WSP Transport Assessment Review No.3

Client: Brookhouse Group Job No: J3250954

Date: 19 September 2023 File Name: TN07 v1.1

WSP Transport Assessment Review No.2

Figure 1.1: Spine Road into Brookhouse Land (source: WSP Drawing 84465-WSP-XX-DR-005)

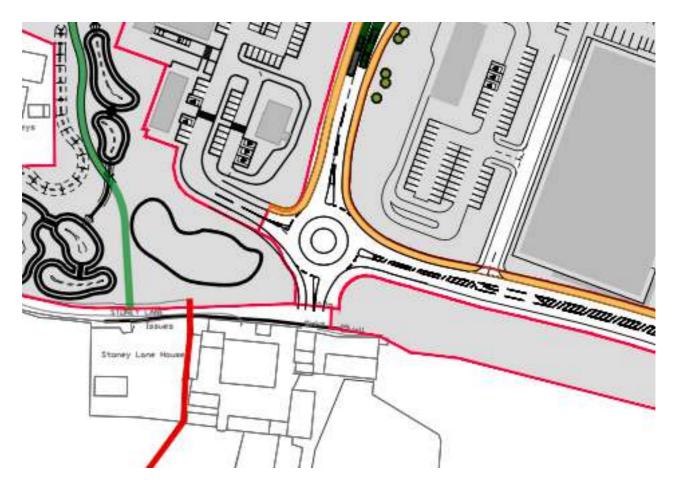
1.2.5 It would appear from the updated drawings that the internal spine road connecting from the north (Zone A) into the Future Phase central parcel of land owned by Brookhouse, has now been provided. As shown in Figure 1.1, WSP's Highways Layout Drawings (1 of 3), the new spine road is now shown to cross over the redline boundary into the central Future Phase plot which it did not do in the previous revisions. This, in addition to the points raised in the covering letter by Barton Willmore, suggested the removal of any potential ransom strip on this Future Phase; an extremely important point which needs to be confirmed within the conditions/ legal agreements to ensure the whole allocation is not prevented from being delivered.

1.2.6 Whilst the connection from Zone A is positive in terms of the Future Phase delivery, the access onto Stanfield Lane now being submitted in detail/ full does not include a link road through Zone D into the central Future Phase plot. This means that the complete through route between M65 Terminus and Stanifield Lane cannot be provided by Brookhouse as part of their future phase and relies on further discussion with the applicant to provide the connection into Zone D, potentially preventing the delivery of the through route.
